3809
UT-047

MEMORANDUM

SUBJECT: Review of Tenneco's Revised Plan of Operations
for Goldstrike Mine

INFLUENCE OF PERCENT SLOPE
ON REVEGETATION

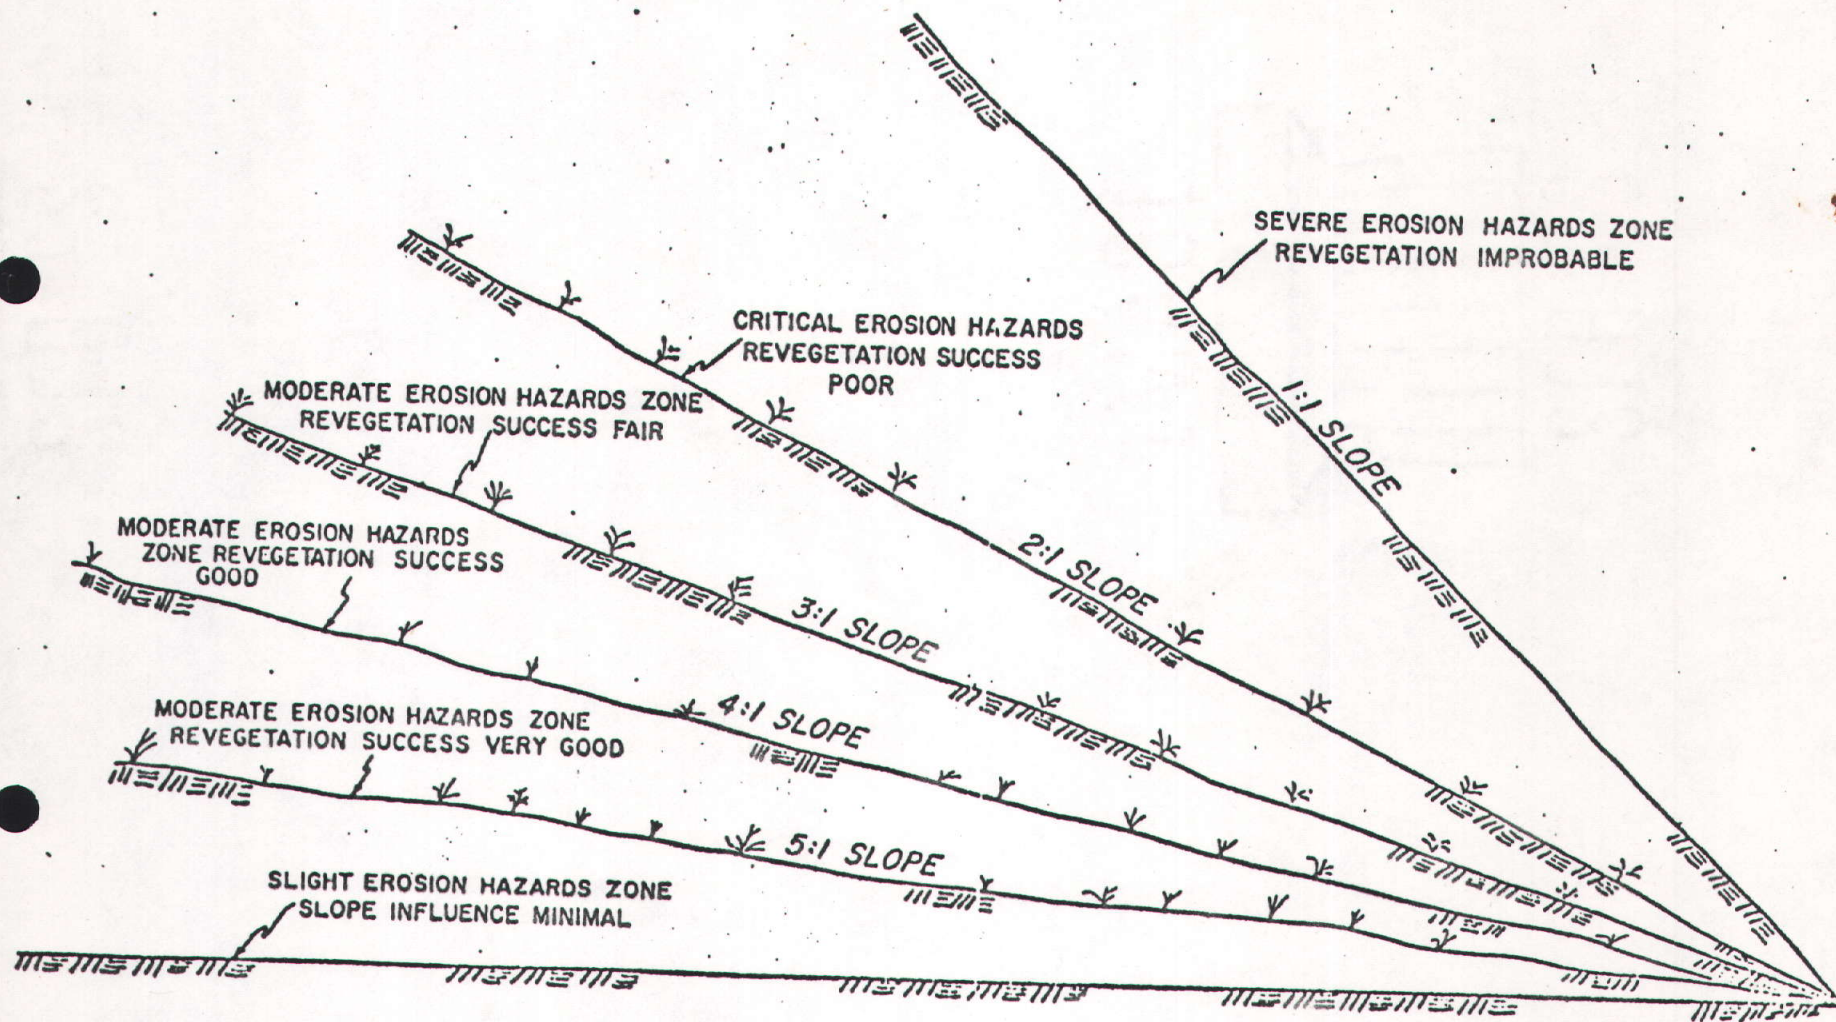
1. It fails to address alternatives to utilizing the natural drainage in Quail Canyon for a heap leach pad.
2. It assumes that the steep slopes up to 33.7 degrees can be successfully revegetated. (In light of the fact that only 6 inches of top soil is available with a rainfall of 12 inches per year, such an assumption appears improper). Our experience suggests that a slope ration of 3 to 1 is normally necessary for successful revegetation.

- A. corrective activities to resolve the 'spills'
- B. an operational procedure that ends up with only one unreclaimed pit
- C. all disturbances draining into a sediment pond
- D. no leach ponds located in natural drainage with any natural flow diverted divided around such areas
- E. an ongoing reclamation process utilizing the option of irrigation.
- F. efforts made to insure the indefinite maintenance of any necessary ditch and debris basins
- G. testing ~~use~~ of the best subsoil as a top soil additive
- H. no respreading of top soil on slopes greater than 3/1
